Questions to
Study on sound level limits of M-and N-
category vehicles
on TFVS-09-06 and TFVS-07-11

10th TFVS meeting
12. July 2022

JAPAN AUTOMOBILE STANDARDS INTERNATIONALIZATION CENTER

Fig26 @TFVS-09-20 Fig72 @TFVS-07-11

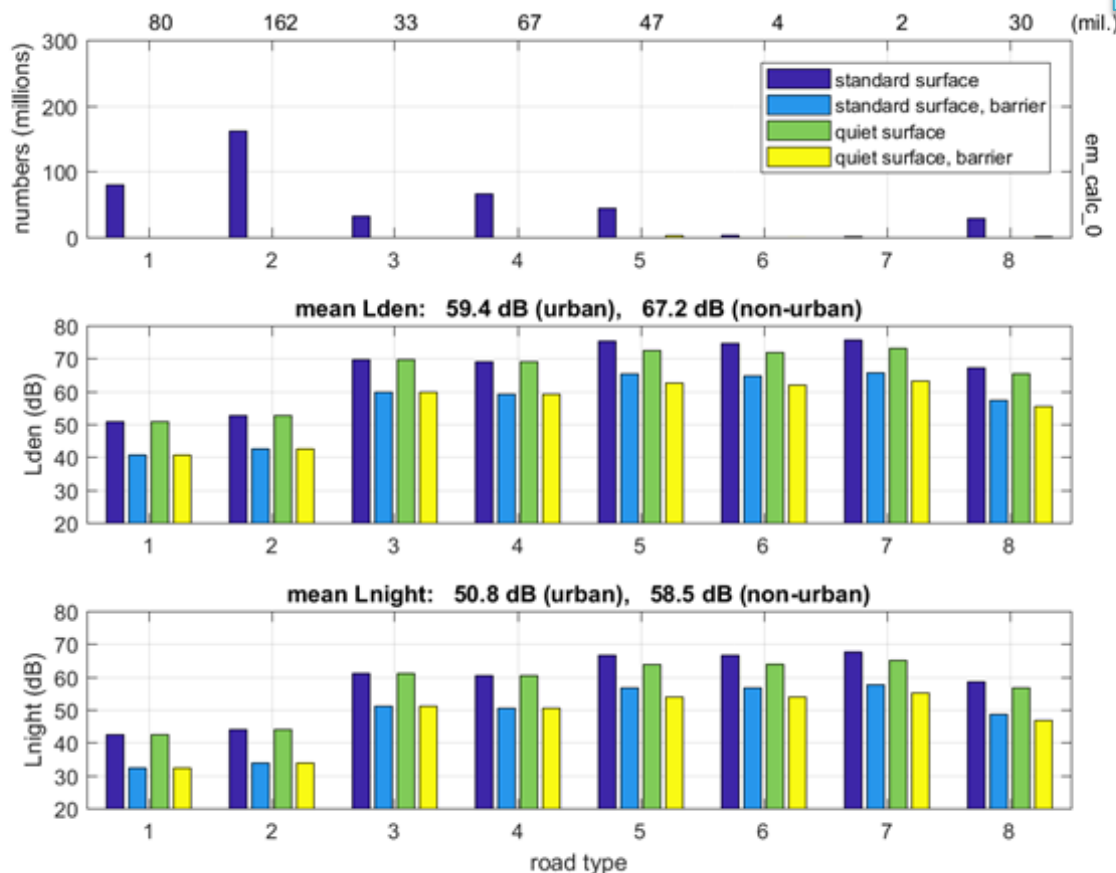
Question;
 What is the standard road surface?
 What is the quiet road surface?

Confirmation;
The road surfaces at road type 1 to 4 are kept standard surface, but not quiet surface.
The Correction coefficient of road surface (Table 46 @TFVS-07-11) are original and different from CNOSSO-EU.

Information;
COMMISSION DIRECTIVE (EU) 2015/996
 — a virtual reference road surface, consisting of an average of dense asphalt concrete 0/11 and stone mastic asphalt 0/11, between 2 and 7 years old and in a representative maintenance condition

Fig26 @TFVS-09-20 Fig72 @TFVS-07-11

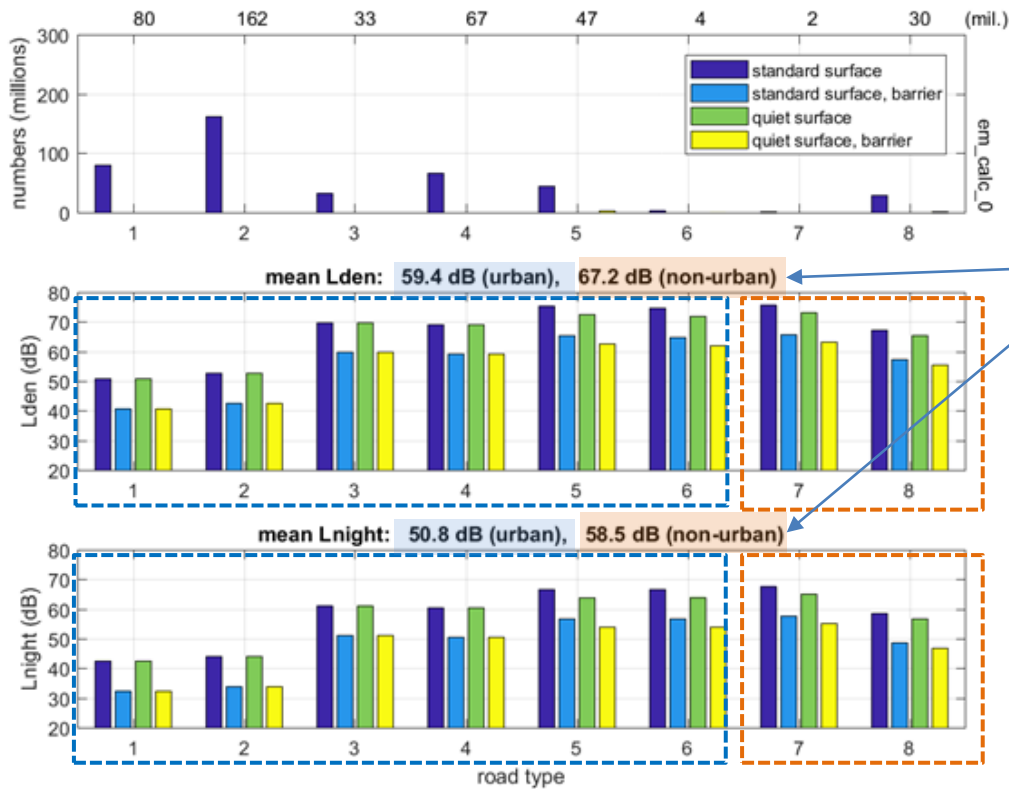
Question;
How to calculate the mean value of Lden and Lnight with different road types?
